# Access Compliance Report

## Public Rights-of-Way

### (Pedestrian Signals)

Intersection ID: N/A	Main Street:	Cross Street: N/A	Location: N/A
ADA ID: 303830A8E7D0	Signal Type: One Push Button-APS	Overall Compliance: No	Severity Score: BTN 1: N/A BTN 2: N/A No BTN: N/A
Codes/Mitigation Info/Possible Solution		Field Measurements/Component Compliance

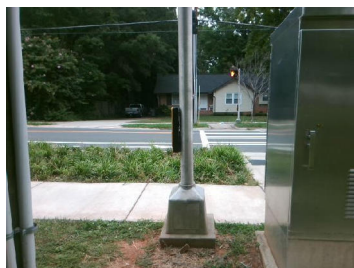
Surveyor Notes: TEXT HT 5/16

PROW/ADA: R410.6, TMUTCD 4e.08, R404.3, R404.1, R404.7.1, R404.7.2,

N/A	B 1 FWD Approach Obstruction?	Yes	N/A	B 2 FWD Approach Obstruction?	N/A
N/A	B 1 FWD Approach Obstruction Dist (in)	4.0	N/A	B 2 FWD Approach ObstructionDist (in)	N/A
No	B 1 PARA Approach?	No	N/A	B 2 PARA Approach?	N/A
N/A	B 1 PARA Approach Constrained?	No	N/A	B 2 PARA Approach Constrained?	N/A
N/A	B 1 PARA Approach Reach (in)	N/A	N/A	B 2 PARA Approach Reach (in)	N/A
N/A	B 1 PARA Approach Width (in)	N/A	N/A	B 2 PARA Approach Width (in)	N/A
N/A	B 1 PARA Approach Obstruction?	Yes	N/A	B 2 PARA Approach Obstruction?	N/A
N/A	B 1 PARA Approach Obstruction Dist (in)	4.0	N/A	B 2 PARA Approach ObstructionDist (in)	N/A
N/A	B 1 Clear Floor Space Slope (%)	N/A	N/A	B 2 Clear Floor Space Slope (%)	N/A
N/A	B 1 Clear Floor Space XSlope (%)	N/A	N/A	B 2 Clear Floor Space XSlope (%)	N/A
N/A	B 1 PAR Slope (%)	N/A	N/A	B 2 PAR Slope (%)	N/A
Yes	B 1 Height (in)	35.5	N/A	B 2 Height (in)	N/A
Yes	B 1 Pressure (#)	2.0	N/A	B 2 Pressure (#)	N/A

Yes B 1 Clear Xing Direction?	ClearlyMarked	N/A B 2 Clear Xing Direction?	N/A
B 1 Crossing Direction	To NE	B 2 Crossing Direction	N/A
Yes B 1 DistanceTo XWalk (in)	19.0	N/A B 2 DistanceTo XWalk (in)	N/A
No B 1 DistanceTo Curb (in)	168.0	N/A B 2 DistanceTo Curb (in)	N/A
Yes B 1 Diameter (in)	2.0	N/A B 2 Diameter (in)	N/A

Possible Solutions: Replace Signal Push Button With APS Button on New Post. Remove & Replace Sign.
